SUBJECT: **Request for Modification to Section 404 Individual Permit and Section 401 Individual Water Quality Certification** for the proposed extension of SR 3000 (Idols Rd.) from SR 2999 (Hampton Rd.) to US 158 (Clemmons Rd.), Forsyth County. Federal Aid Project No. STP-3000 (1), State Project No. 8.2624101, T.I.P. Project No. U-2707. Debit \$570.00 from WBS Element No. 34845.1.1.

REFERENCE: Individual Permit Application dated May 4, 2012.
Section 404 Individual Permit issued November 5, 2012.
Section 401 Individual Water Quality Certification issued August 6, 2012.

Permit Drawing Sheet 8 of 15
Revised 8/24/2016

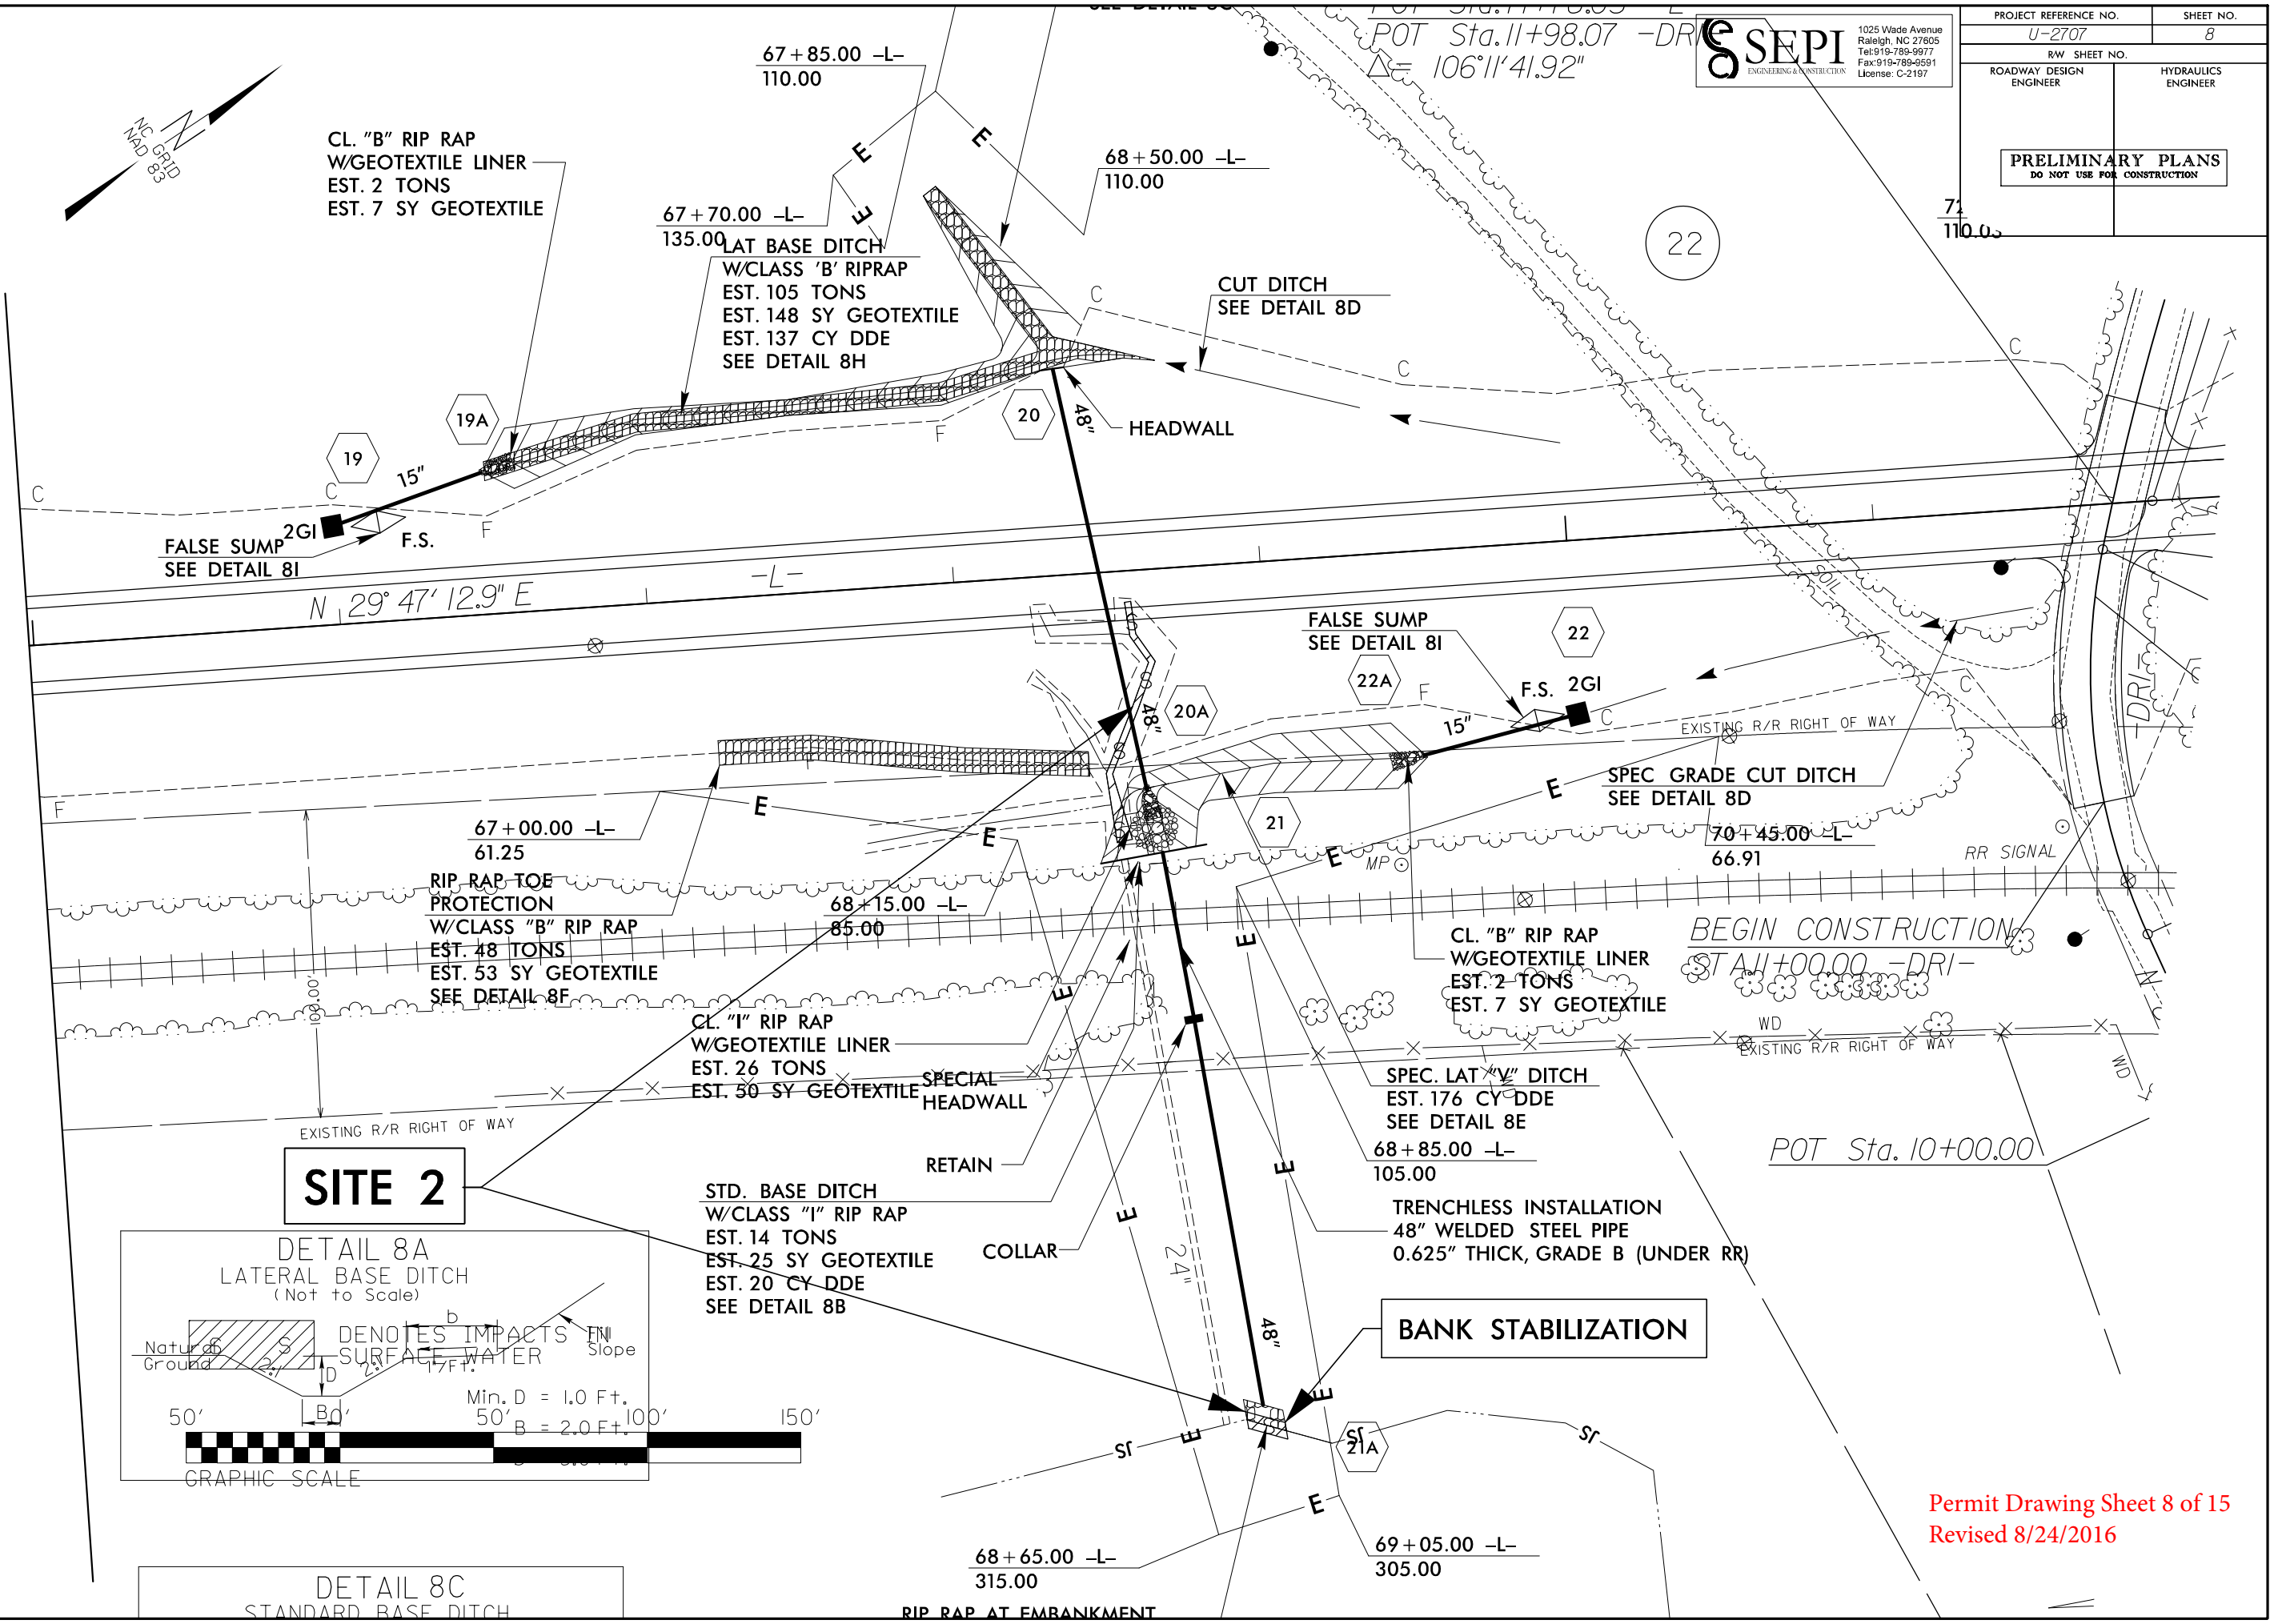
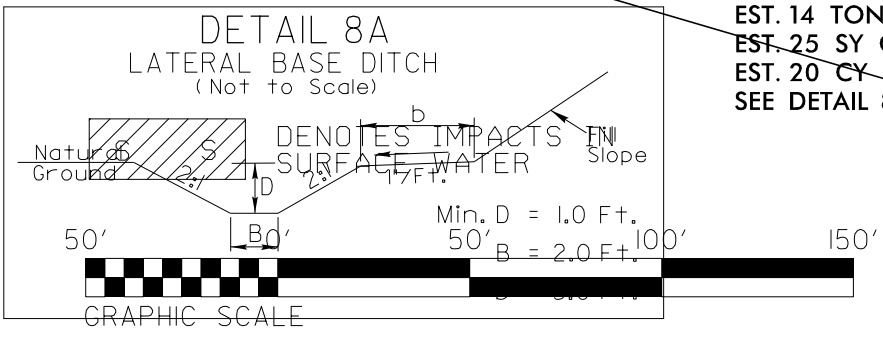
The original permit application dated May 4, 2012, stated the impacts at Permit Site 2 are from the relocation of a jurisdictional stream into a series of two new 48" pipes. Permanent impacts from 14 lf of bank stabilization at the outfall of the second 48" pipe were not included in the original submittal (See Revised Permit Drawing Sheet 8 - attached). The receiving stream below the 48" pipe was not depicted on the original permit drawings but will not be impacted by this action. Permit Site 5 had no impacts in the original submittal. A damaged pipe was to be replaced with a pipe with baffles to enhance fish passage and this enhancement would offset any permanent impacts. The damaged pipe will now be removed without replacement. A 48" temporary pipe will need to be installed at the same location for a temporary crossing for equipment access in the construction of the bridge to the south. Temporary impacts of <0.01 acre

Permit Drawing Sheet 10 of 15
Revised 8/24/2016

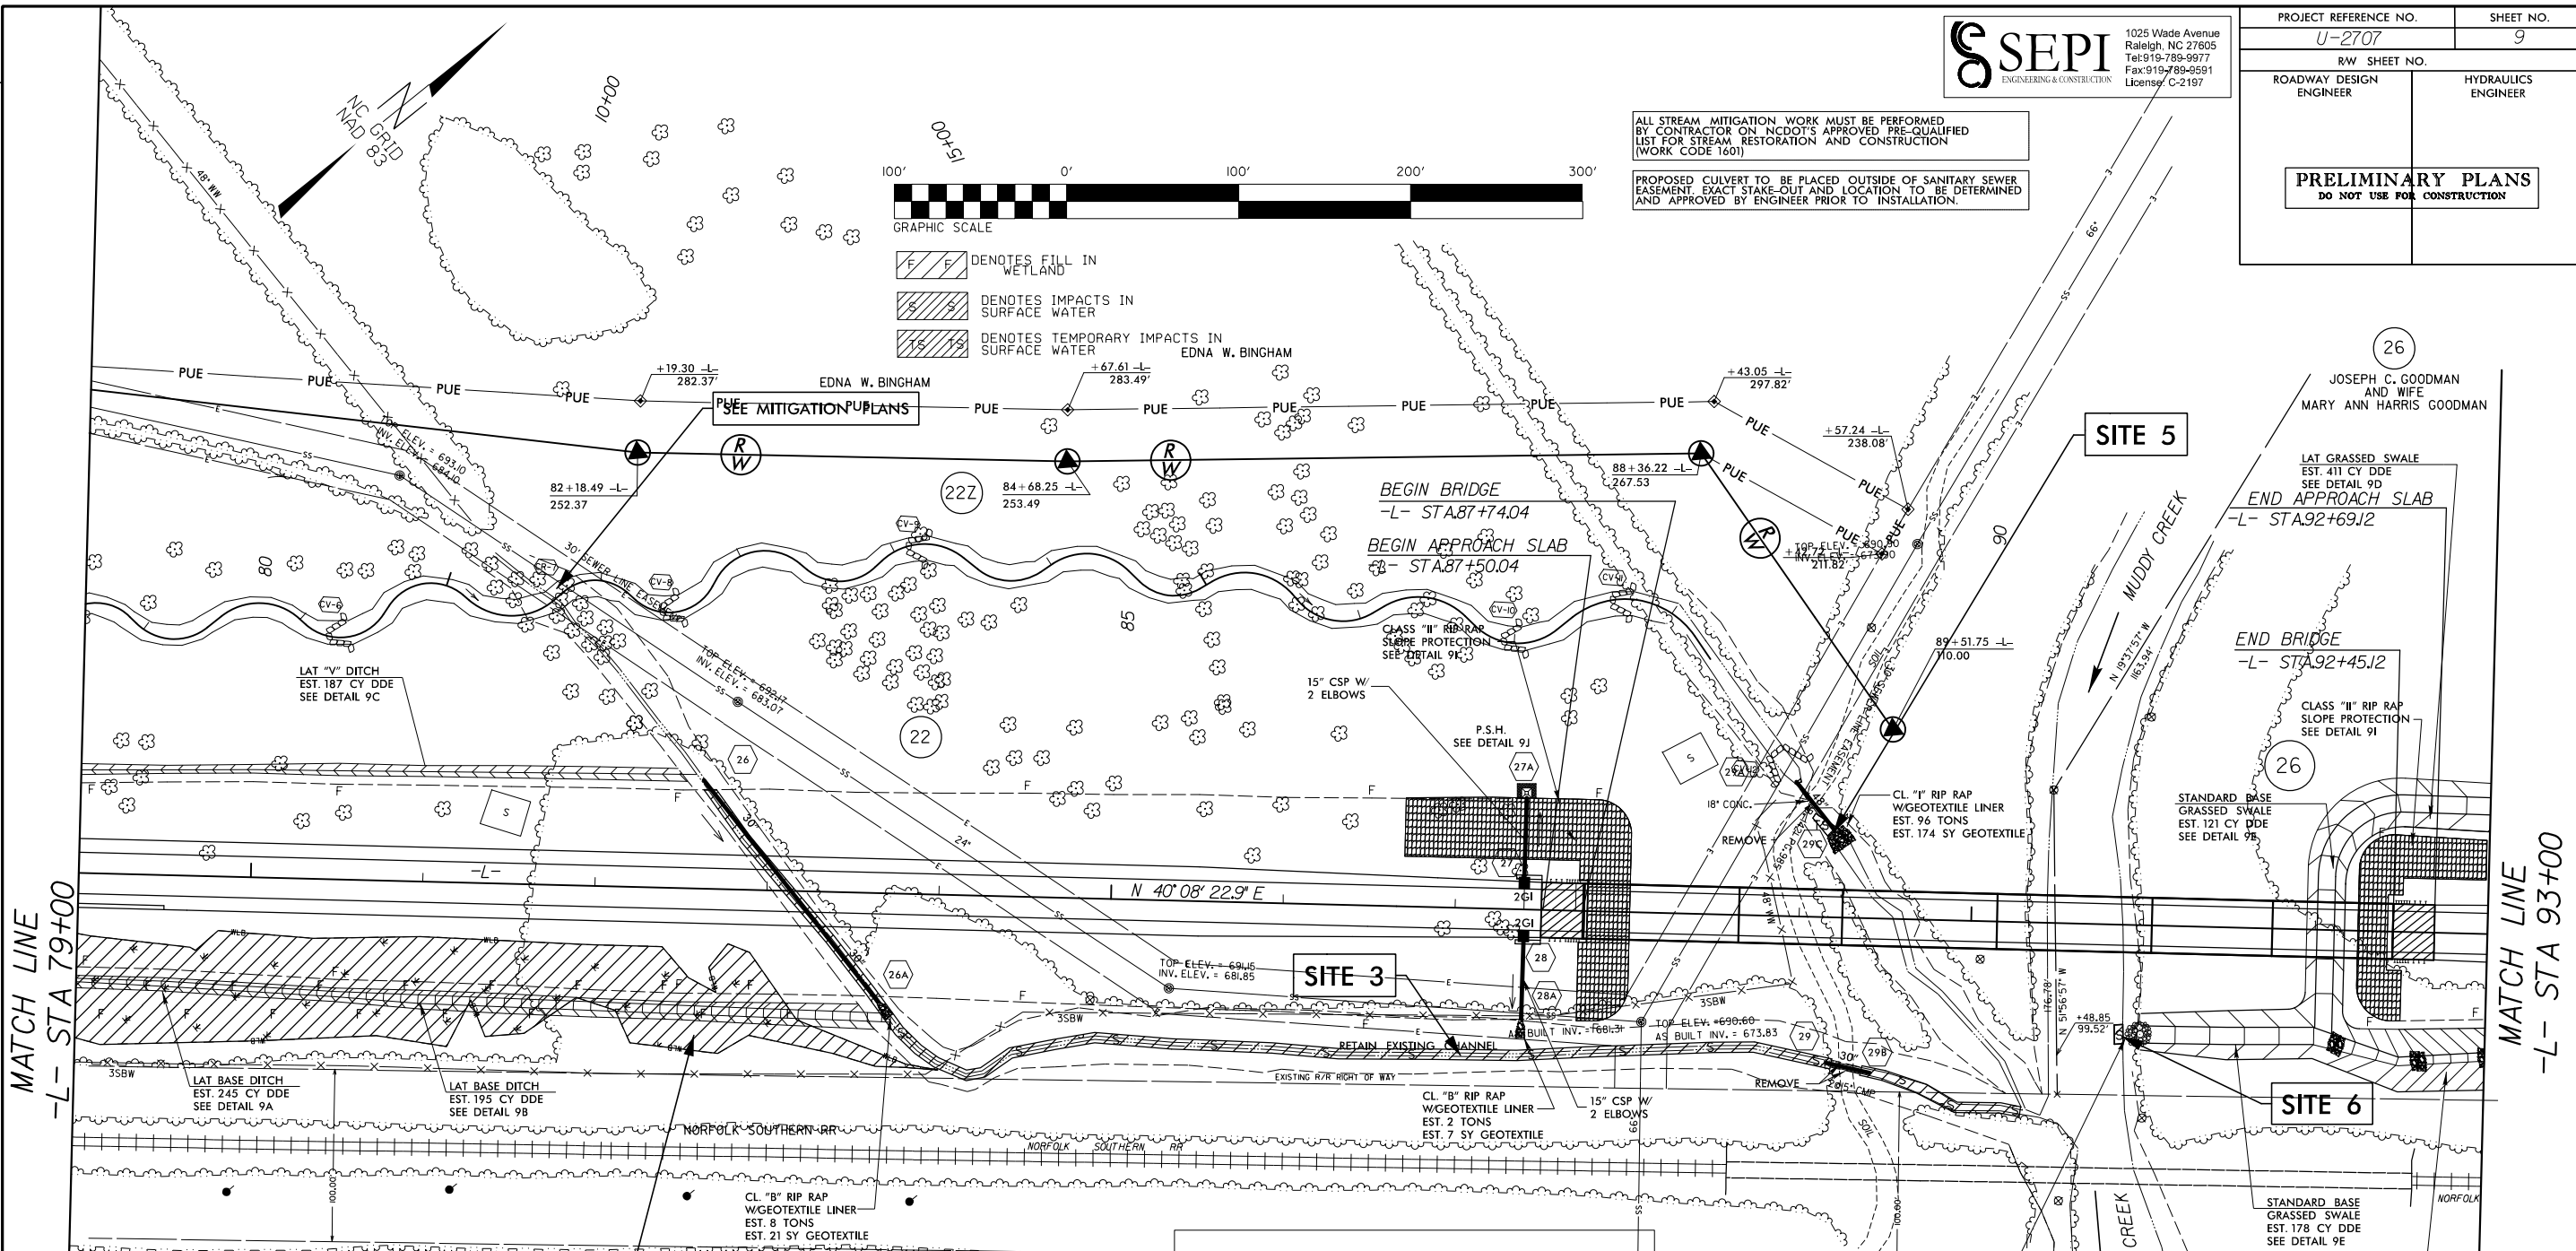
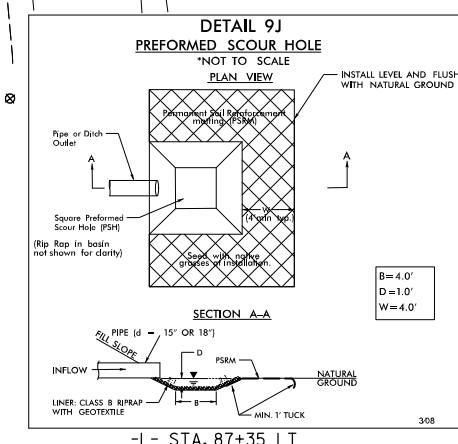
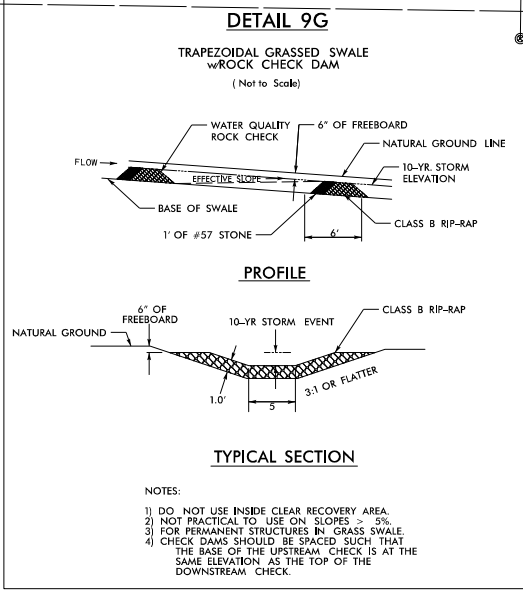
(50 lf) will result from this action (see Revised Permit Drawing Sheet 10 and the Revised Impact Summary Sheet - attached).
